**Ladder Diagrams for Error  
Recovery For FCP -2 Rev 04  
Out-Of-Order Delivery- Annex D**

**T10/00-137r2**

Reference: T11/00-133v1

# Summary of Major Changes

# D.14b Class 3, SRR Response Lost

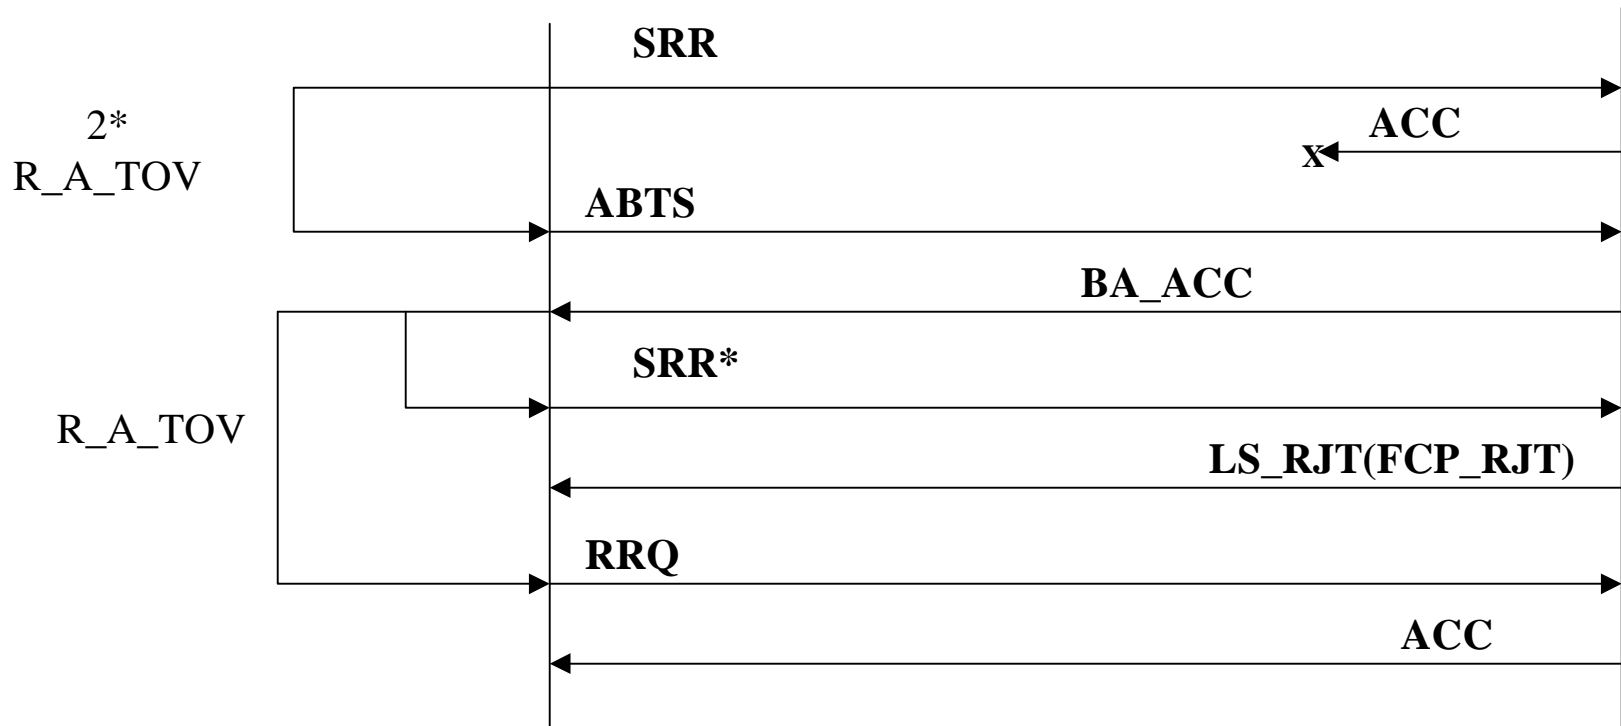
Change E\_D\_TOV in the test to  $2^*R\_A\_TOV$  to agree with the text in 12.6.3
